24590-LAW-P1-P01T-00001

LAW VITRIFICATION BUILDING GENERAL ARRANGEMENT PLAN AT EL. (-) 21'-0"

SCALE: 1/16"=1'-0"
24590-LAW-P1-P01T-00001
REV 4

PLAN AT EL (-)21'-0"

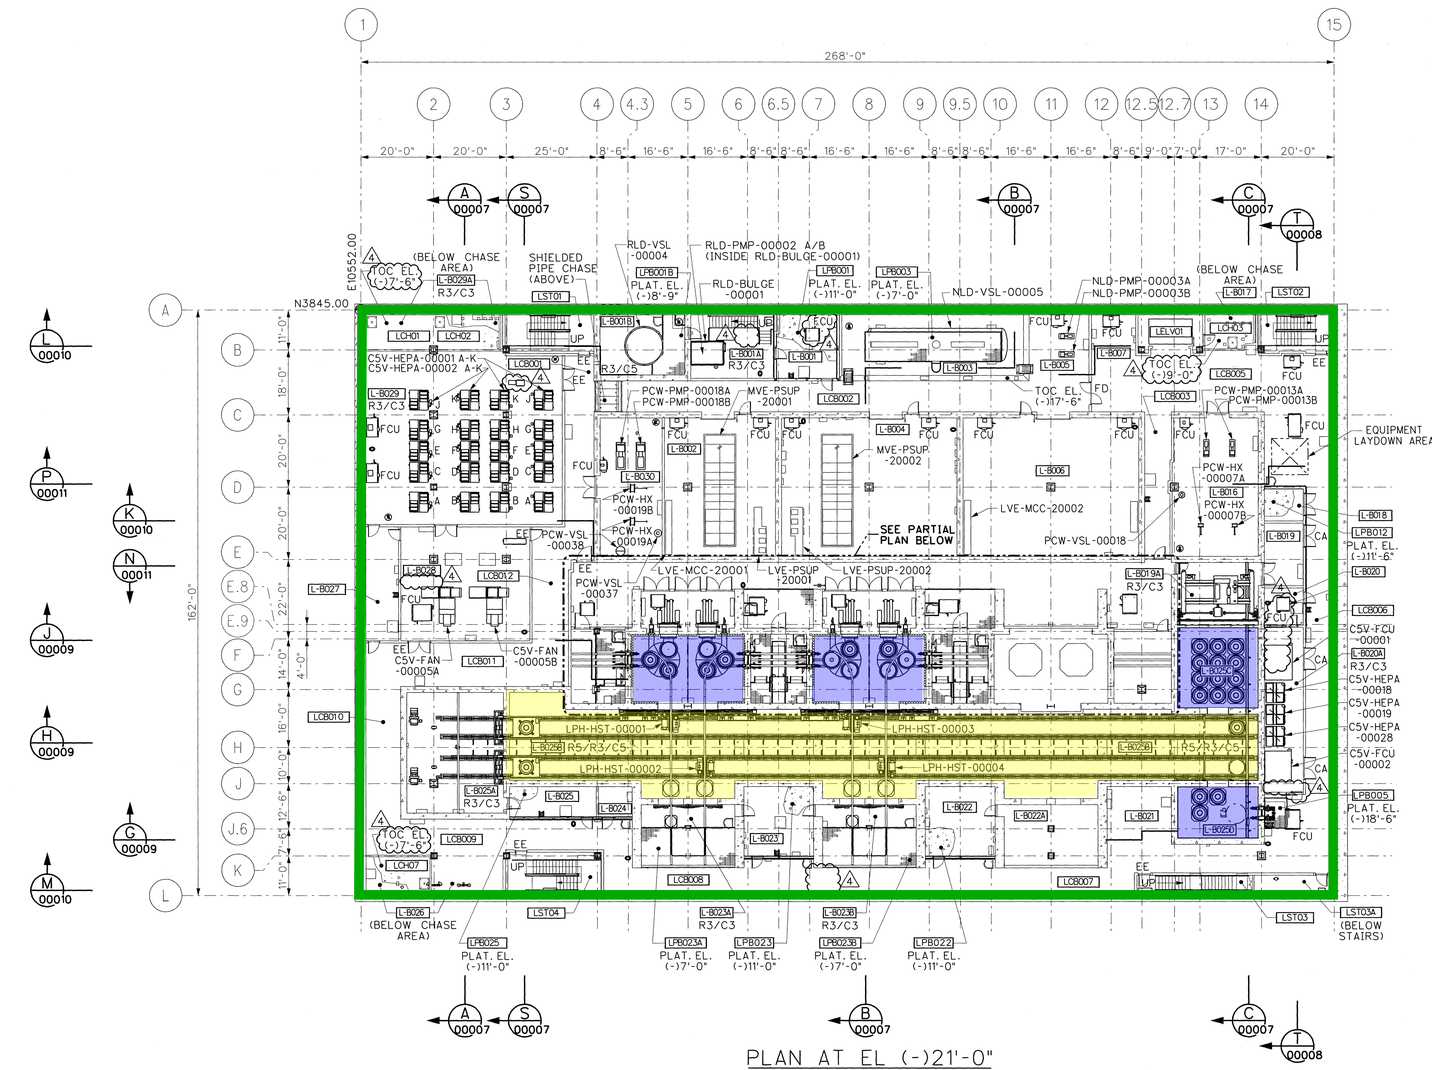
24590-LAW-A1N-A10T-00032: DELETED PARTITION WALL AND DOOR NEAR COLUMN LINE E.5/11 AND DOOR NEAR COLUMN L/7.

24590-LAW-P1N-P01T-00064: RELOCATED C3V-FCU-00014/18/39.

24590-WTP-FC-C-08-0749: RELOCATED PARTITION WALL AND DOOR NEAR COLUMN LINE E.9/12.5.

24590-WTP-FC-C-13-0064: REMOVED PARTITION WALL AND DOOR AT COLUMN E/12 IN ROOM LB009.

RELOCATED SOUTH WALL OF L-B020A 1'-0" SOUTH.

ADDED TOC CALLOUTS FOR CLARITY.

REVISED RADIATION/CONTAMINATION CLASSIFICATION FOR L-B028 TO R2/C2 PER CCN 254517.
